## Justification For Deviations - NUREG-1431 Section 3.01.08

09-May-01

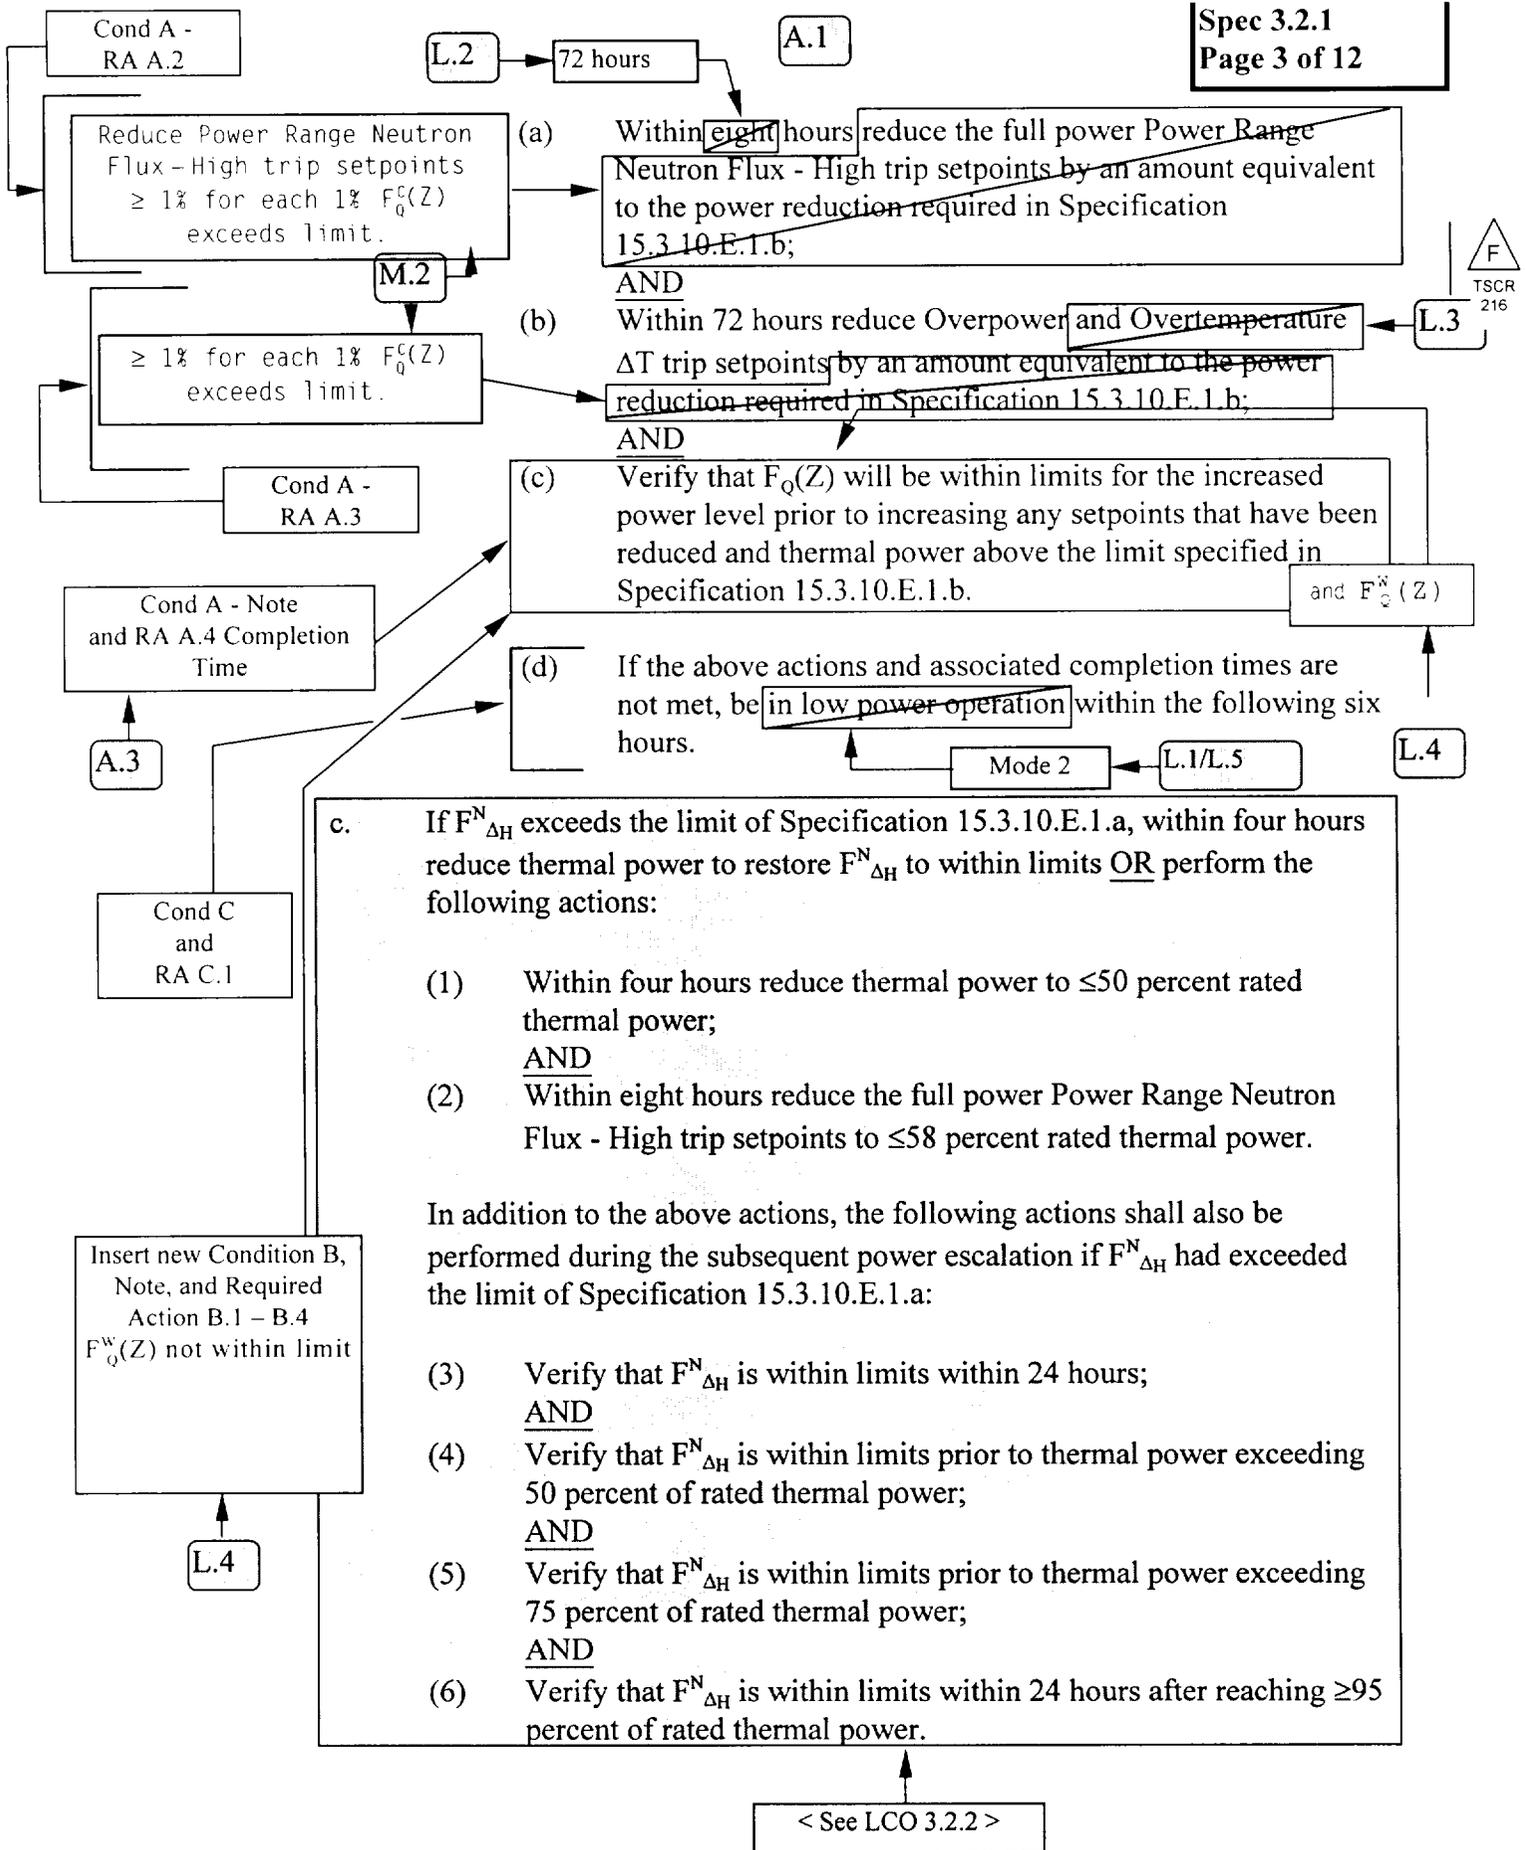
b. If  $F_Q(Z)$  exceeds the limit of Specification 15.3.10.E.1.a, within fifteen minutes reduce thermal power until  $F_Q(Z)$  limits are satisfied

(1) After thermal power has been reduced in accordance with Specification 15.3.10.E.1.b, perform the following actions:

LA.1

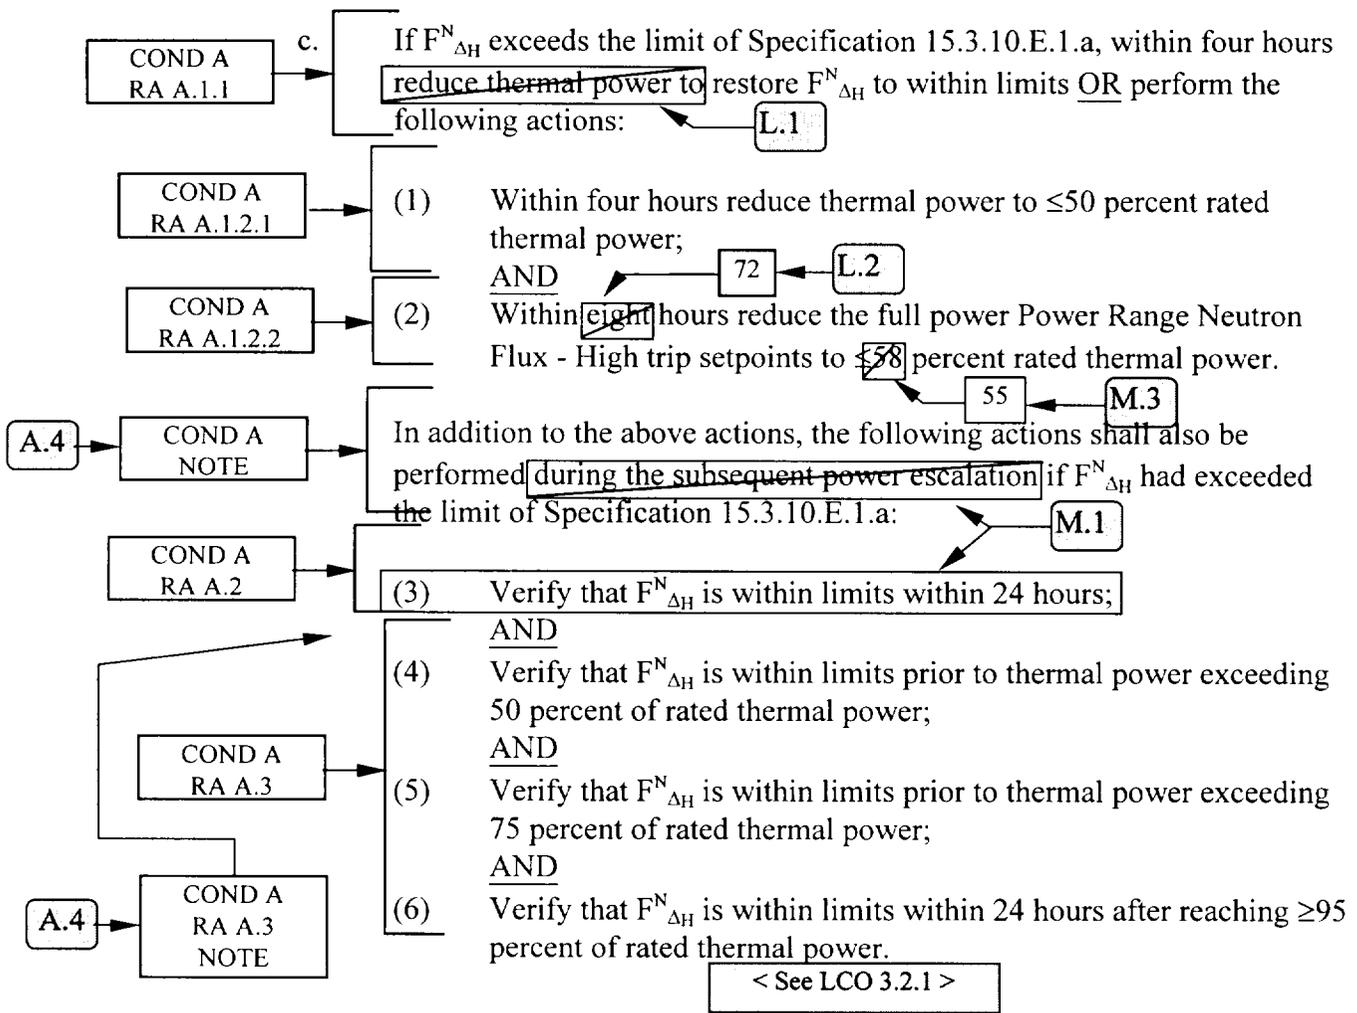
Moved to COLR

FIGURE 15.3.10-4  
FLUX DIFFERENCE  
OPERATING ENVELOPE  
POINT BEACH UNITS 1 AND 2

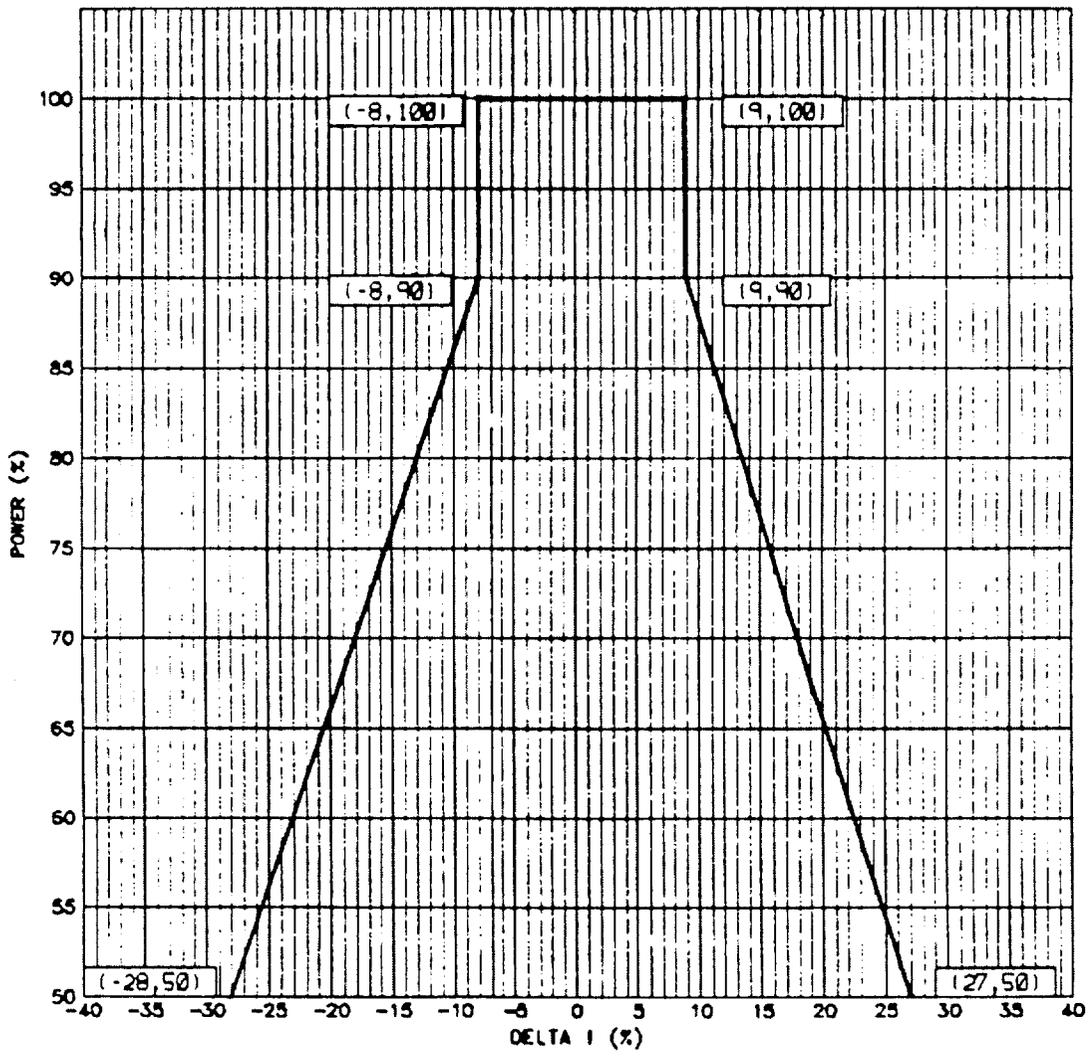
a. During power operation with thermal power  $\geq 50$  percent of rated thermal power, the axial flux difference shall be maintained within the limits specified in Figure 15.3.10-4, the COLR.
